SUBJECT: CYCLE 5 RELOAD - PALISADES PLANT

Amendment No. 68
License No. DPR-20

ATTACHMENT TO LICENSE AMENDMENT NO. 68

SAFETY EVALUATION BY THE OFFICE OF NUCLEAR REACTOR REGULATION
SUPPORTING AMENDMENT NO. 68 TO PROVISIONAL OPERATING LICENSE NO. 20
CONSUMERS POWER COMPANY
PALISADES PLANT
DOCKET NO. 50-255

FIGURE 3.11-1

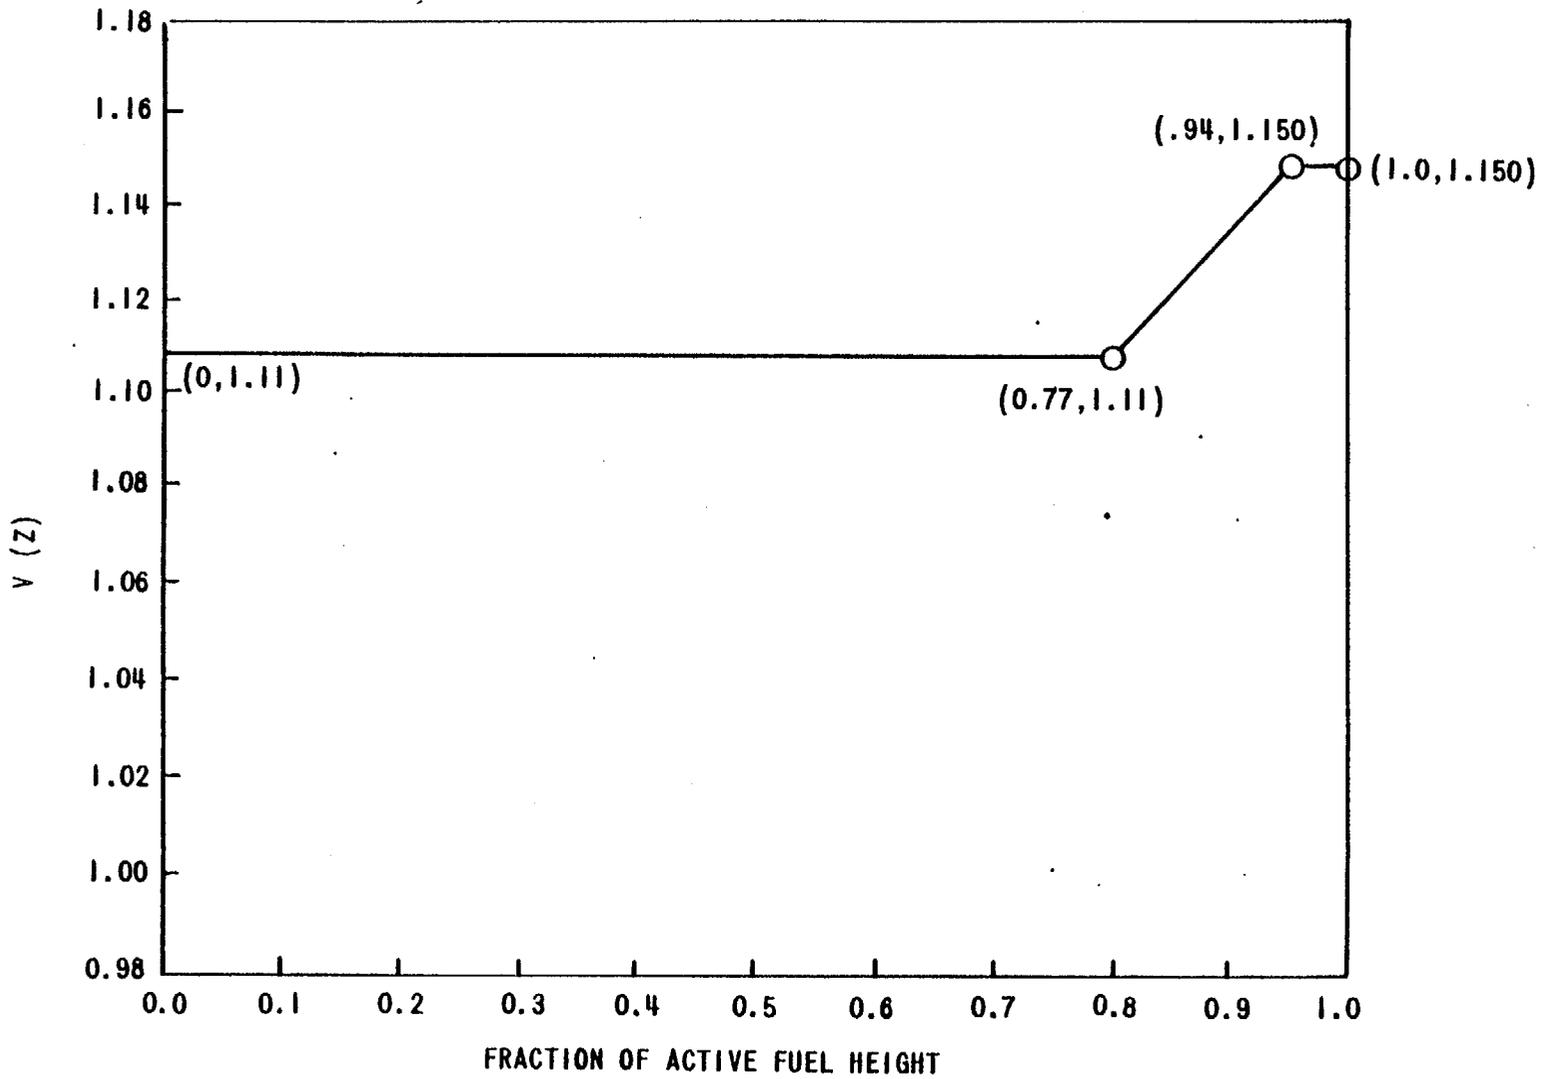
Proposed TS 3.11.2 defines the operability requirements for the excore detector system. What is proposed allows monitoring of the LHR limits with the excore detectors as an alternative to the present incore monitoring system when operability requirements of the incores cannot be met. The method employed is based on Exxon Nuclear Company's PDC-II as reported in Reference 7. This topical report has been approved by the staff. In PDC-II, the largest peaking factor which can occur in normal operation of the power plant is determined by multiplying predetermined transient components of the peaking factor by the measured steady state peaking factors of the reactor. This is done as a function of axial height. The most limiting ratio of these peaking factors converted to LHR over LHR limit determines an allowed power level which can be permitted using the excore detectors. The active role of the excore detectors in PDC-II is to maintain operation of the reactor within a narrow axial offset band around a target axial offset. This is done because such operation is assumed in prediction of the transient component of the peaking factor.

FIGURE 3.23-2

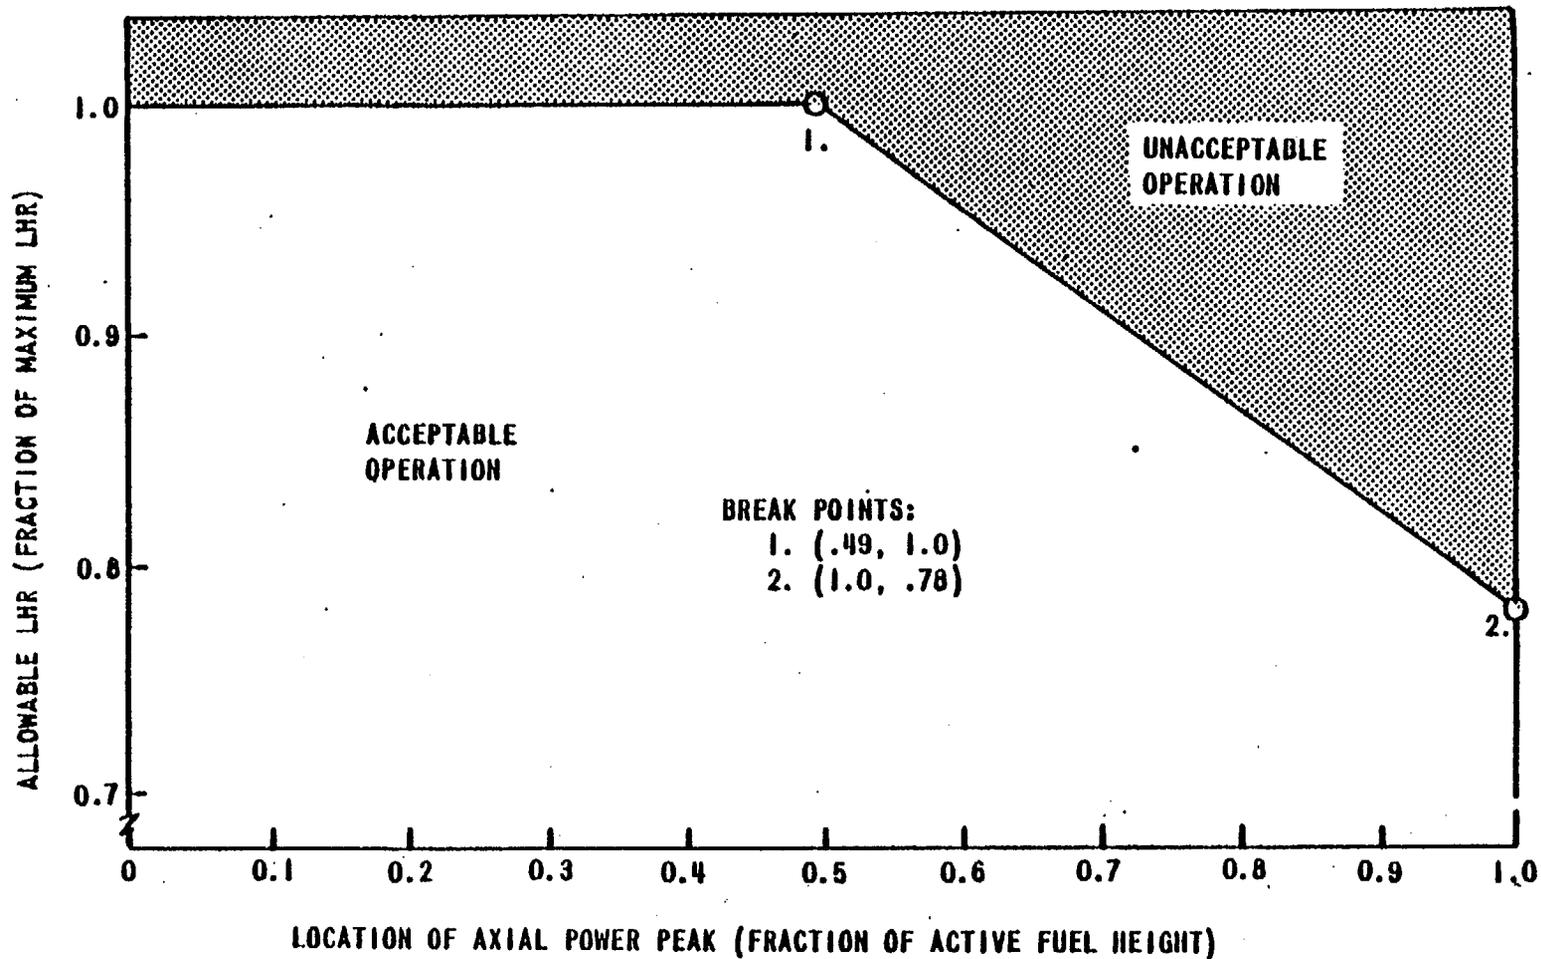
The results of this analysis are incorporated into the LHR limit of TS 3.23.1 via the dependence on Figure 3.23-2. This TS applies to all fuel in the core, and will apply to the fuel in future reloads if it is mechanically similar to the batch H fuel.

During Cycle 5 batches H and I fuel will not receive enough exposure to be limited by TS Figure 3.23-2. The batch G fuel is sufficiently depleted that its LHR will most likely fall below the limit imposed by TS Figure 3.23-2, and probably no special measures will be required to limit the power in the batch G fuel assemblies.

FIGURE 3.23-1

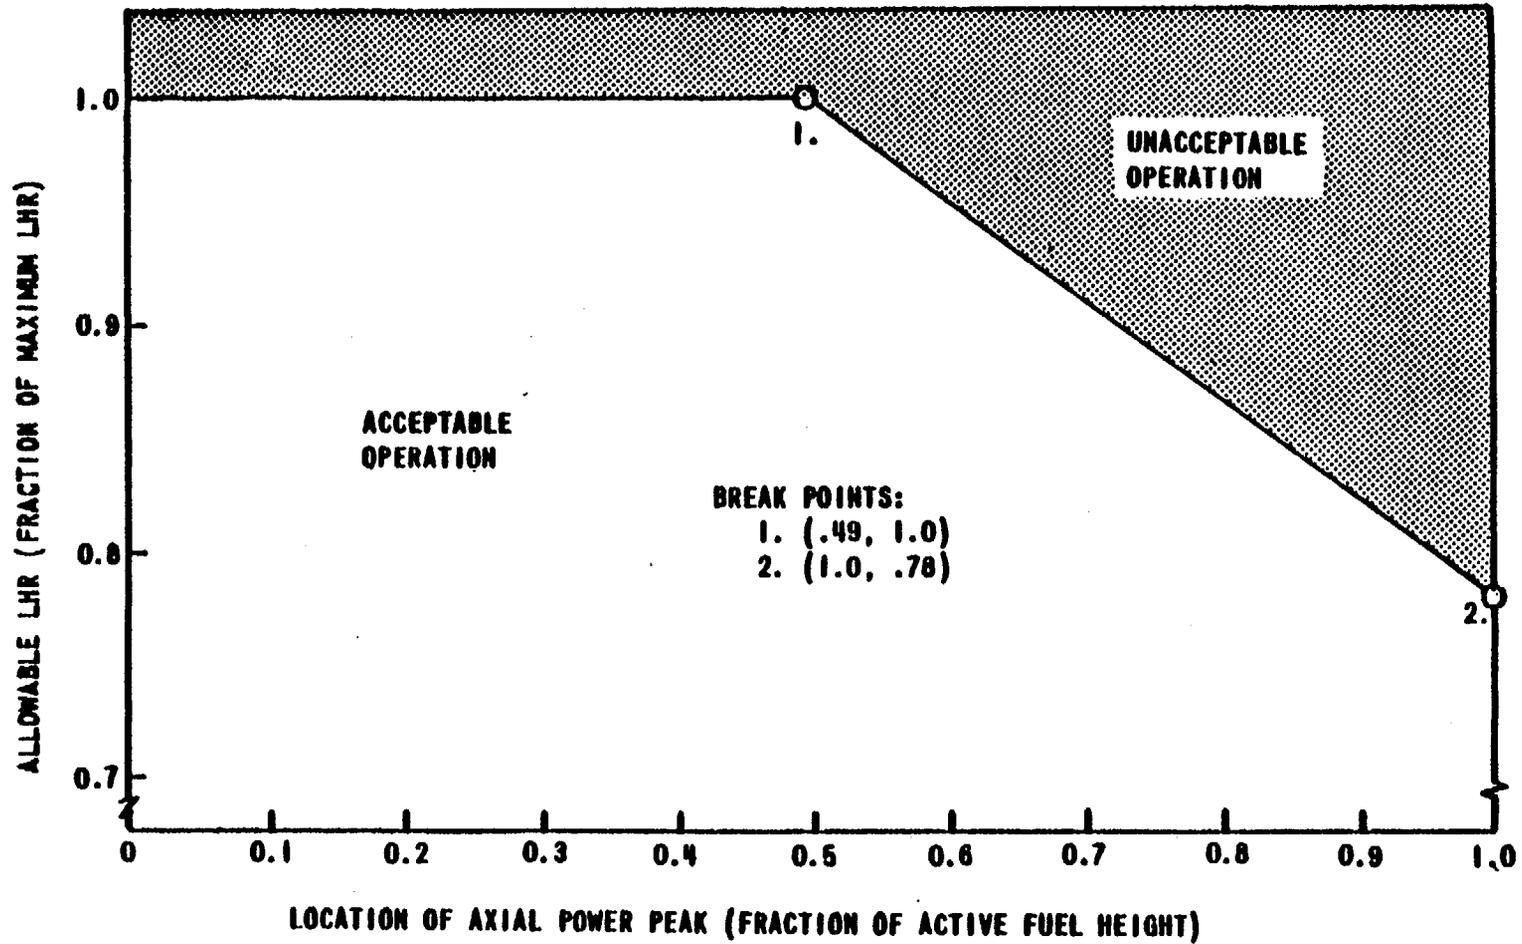
TS Figures 3.23-1 and 3.23-3, which are included here, define the new TS PLHR limit.

The LOCA analysis in the Axial Shape Report has been the reference LOCA analysis for Cycles 4 and 5. The value $\{PLHR(\frac{Z}{L} \leq 60\%)\} = 15.28 \text{ KW/FT}$ and TS Figure 3.23-1 were both generated from analyses in the Axial Shape Report and any LOCA reanalysis must encompass a reevaluation of both of these items. Unlike the transient analysis case, for the LOCA analysis there is no simple TS adjustment (such as demanding MDNBR = 1.30 at 15% overpower) which will bring Cycle X in line with the reference LOCA analysis. But rather, all the Cycle X LOCA analysis input parameters must be less adverse than the reference LOCA analysis input parameters for the reference LOCA analysis to be bounding.

TS Figure 3.23-1 was derived assuming $\{F_r^A\} = 1.45$ and $\{F_r^P\} = 1.77$, and thus far in this discussion the validity of TS Figure 3.23-1 for other radial peaking factors has not been considered. Ideally TS Figure 3.23-1 would be valid for any set of radial peaking factors and, for that matter, for any LOCA input parameters different from those used in the reference LOCA analysis. If this is the case, then if a LOCA reanalysis becomes necessary, the only

To date Palisades has presented one example which shows the validity of TS Figure 3.23-1 for inputs other than those used in the reference LOCA analysis. In Reference 26 (herein called the Corner Pin Report) LOCA analyses were performed with $\{F_r^P\} = 1.90$, rather than the reference LOCA analysis value of $\{F_r^P\} = 1.77$. In the Corner Pin Report, $\{PLHR(\dot{Z}/L = 60\%)\}$ and $\{PLHR(\dot{Z}/L = 80\%)\}$ were computed, and the ratio between these two [PLHR] matched TS Figure 3.23-1 perfectly.

The above example hardly constitutes proof that TS Figure 3.23-1 is valid for any set of LOCA analysis inputs, and any future LOCA reanalyses should be done with at least two \dot{Z} values to verify that TS Figure 3.23-1 remains valid. However the excellent results obtained in this example give good reason to expect that other examples will verify that TS Figure 3.23-1 is valid for a wide range of LOCA input values.
